# ***Final Value Engineering Study Report***

## ***I-5 Aurora – Donald Interchange***

***Oregon Department of Transportation***

***CN B36771***

Figure 2 – Phase 1 Concept incorporating Accepted VE Alternatives

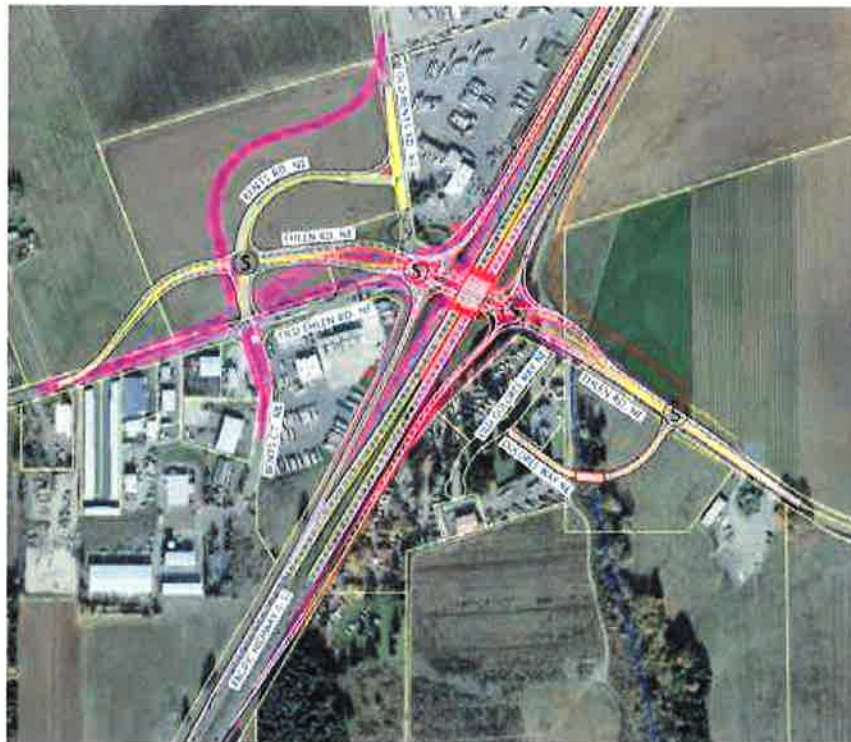
The VE team identified alternatives to address both Phase 1 and Phase 2 of the project. The VE team identified six different options to consider for Phase 1 but ultimately VE Alternatives 15.0 and 18.0 were accepted resulting in a modified concept that will improve interim functionality for the initial build of the project. Both alternatives would address off-ramp queuing issues for both northbound and southbound I-5 while provide operational benefits to Ehlen Road. This interim Phase 1 concept is illustrated in Figure 2.

Figure 3 – Phase 2 Concept incorporating Accepted VE Alternatives compared to Baseline Concept (pink)

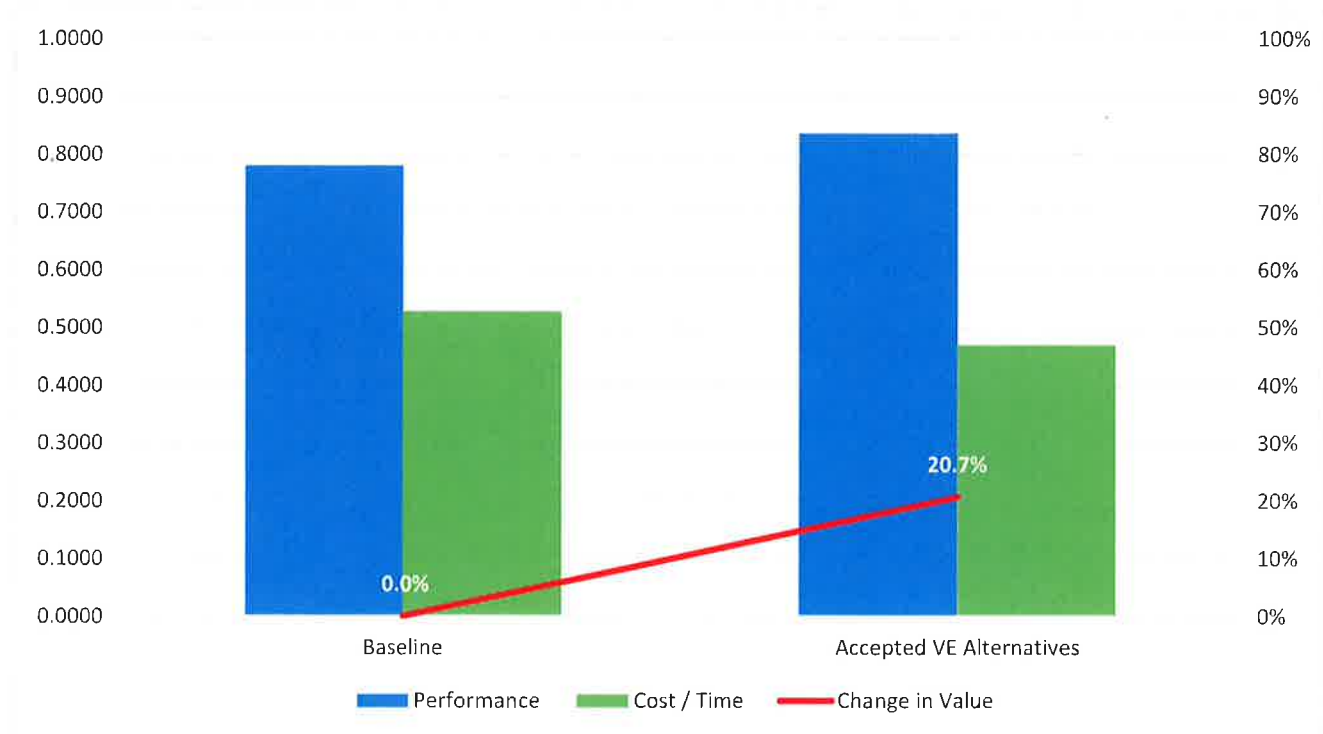
VE alternatives 3.0 and 4.0 were considered the most important alternatives that would reduce cost while improving operational performance on Ehlen Road and reducing construction impacts to I-5 by improving the geometry of the DDI. VE Alternative 6.0 offers additional improvement to reduce queues for the northbound I-5 off-ramp. In summary, the eight recommended Phase 2 VE alternatives could reduce project costs by just over \$12.5 million, reduce the construction schedule by 10 months, and provide a small performance improvement while mitigating a number of key risks, including potential impacts to the BPA transmission towers. The ultimate Phase 2 build out is illustrated in Figure 3.
